PRELIMINARY DRAINAGE PLAN
PUDSP 20-XX ← 21-002
EGP 20-XX

SKYLINE AT LORSON RANCH

**PCD-ENGINEERING REVIEW COMMENTS
IN BLUE BOXES WITH BLUE TEXT**

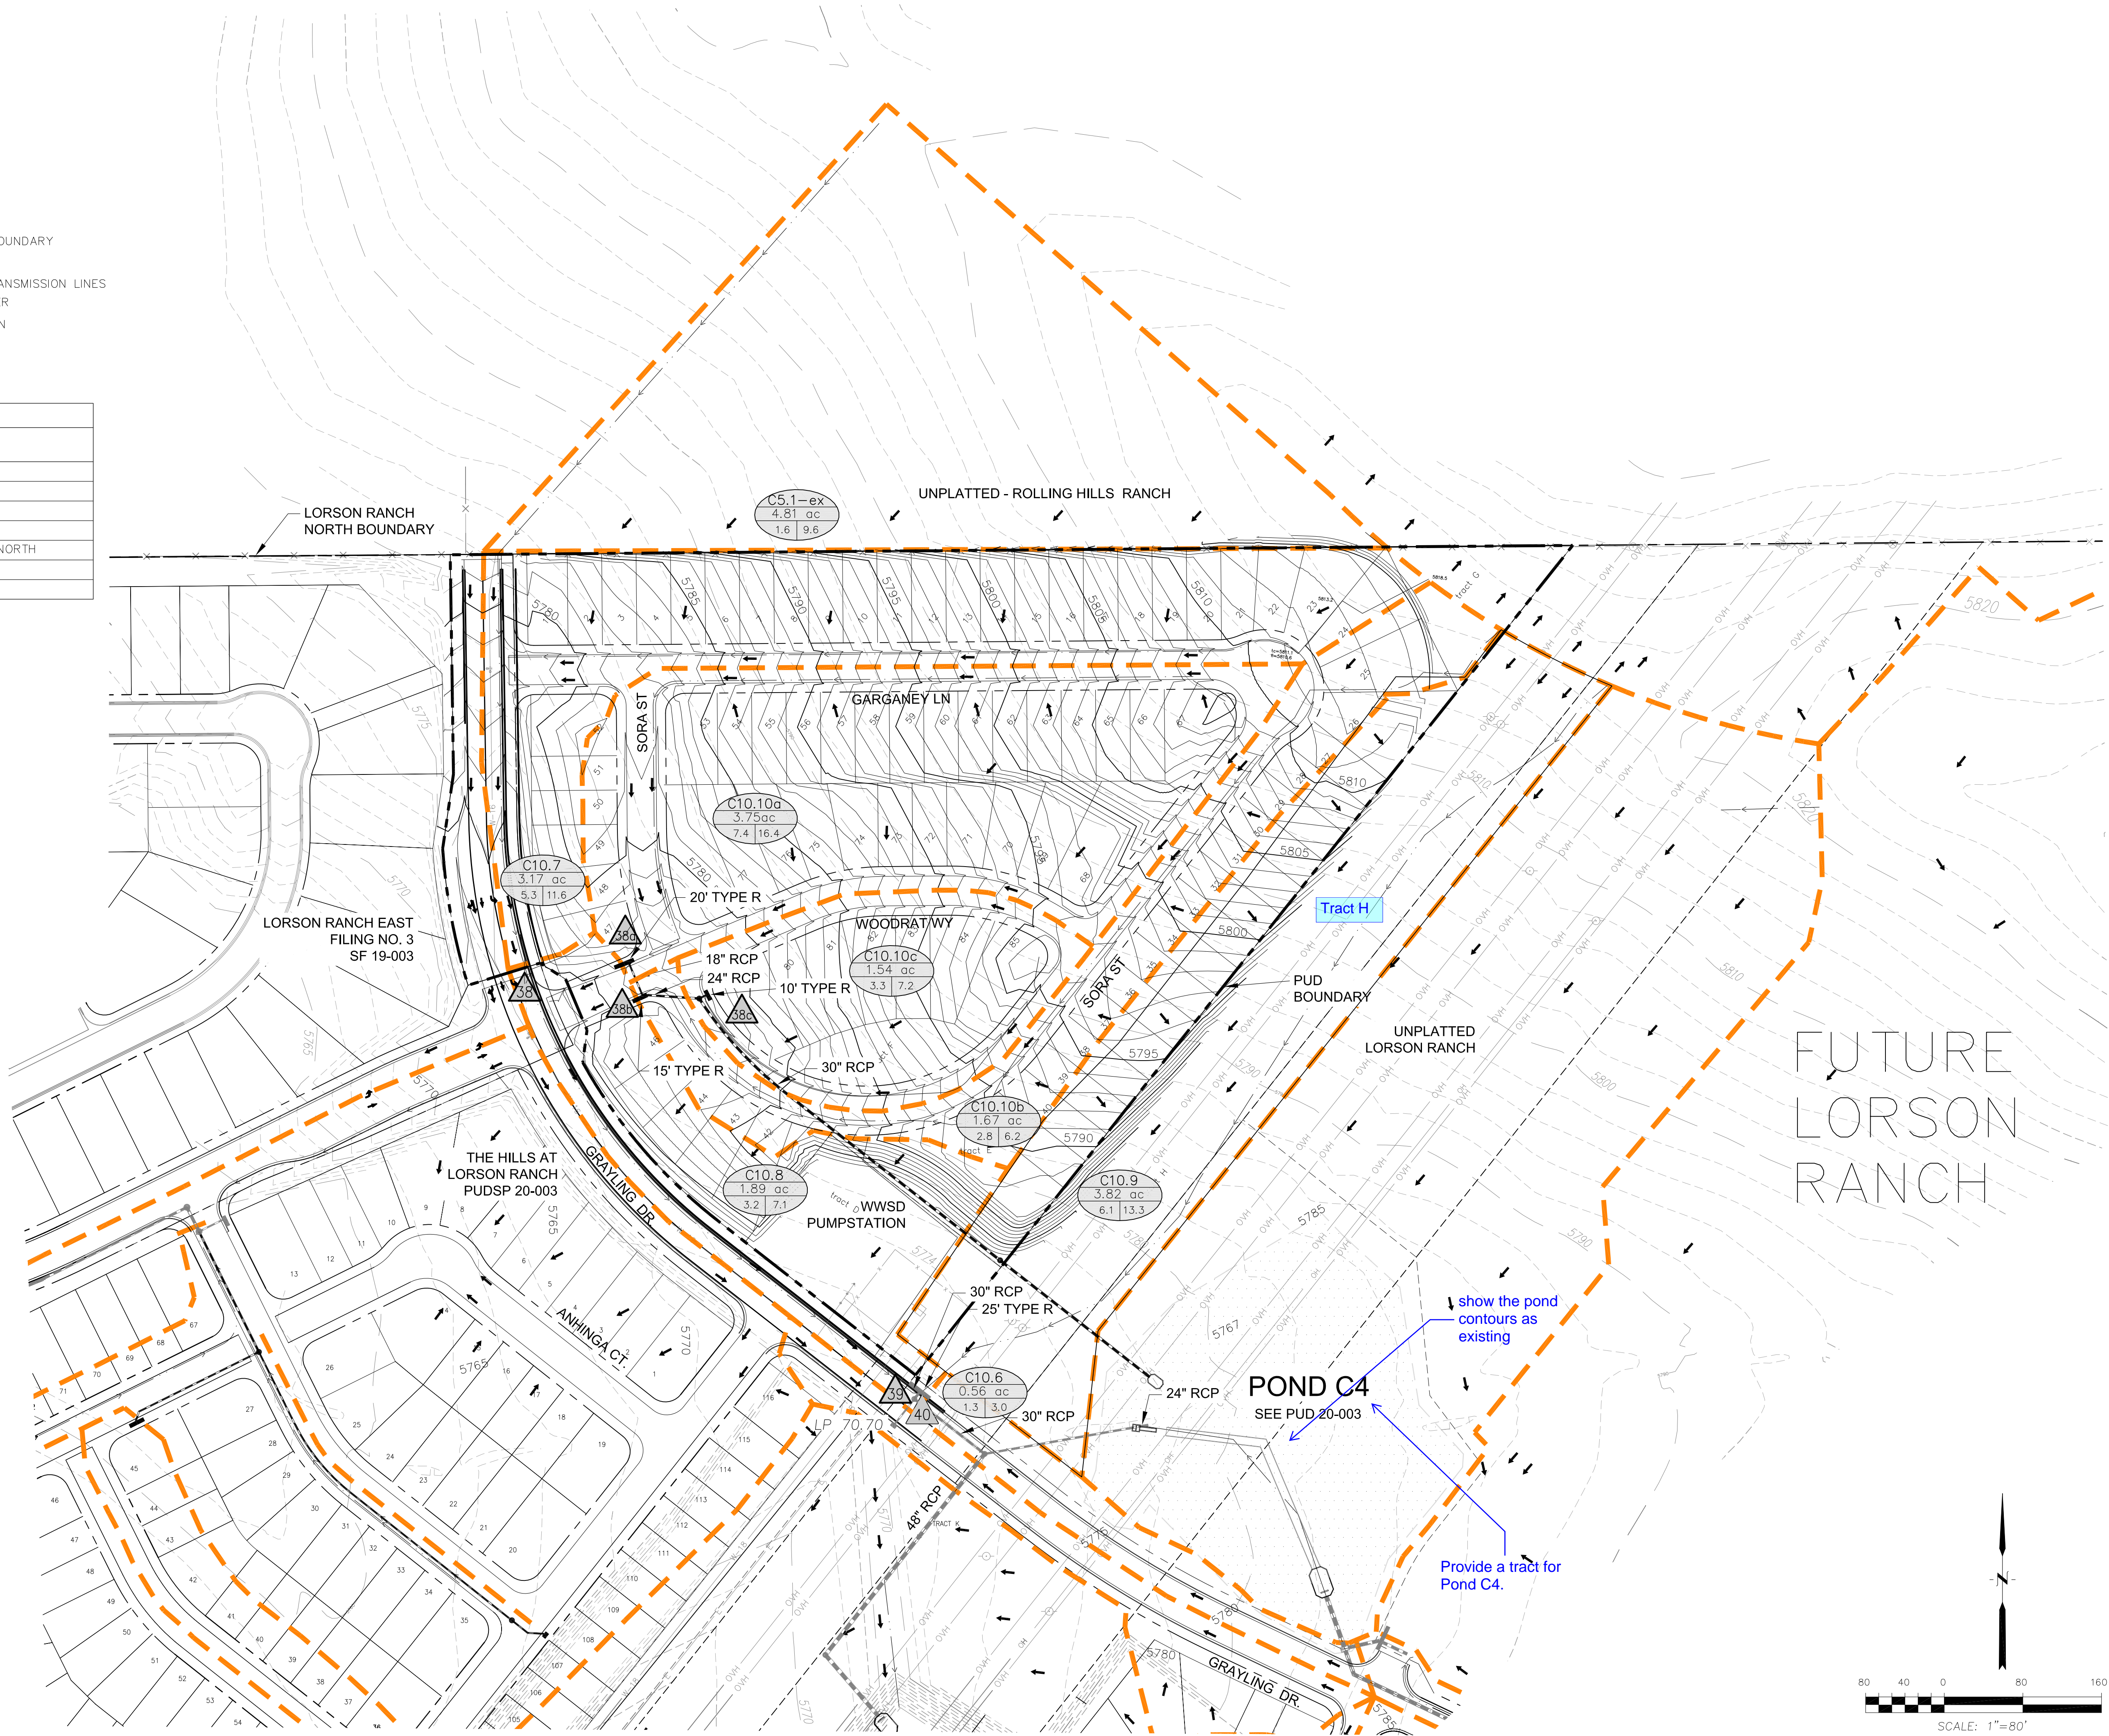
show the pond contours as existing

Provide a tract for Pond C4.
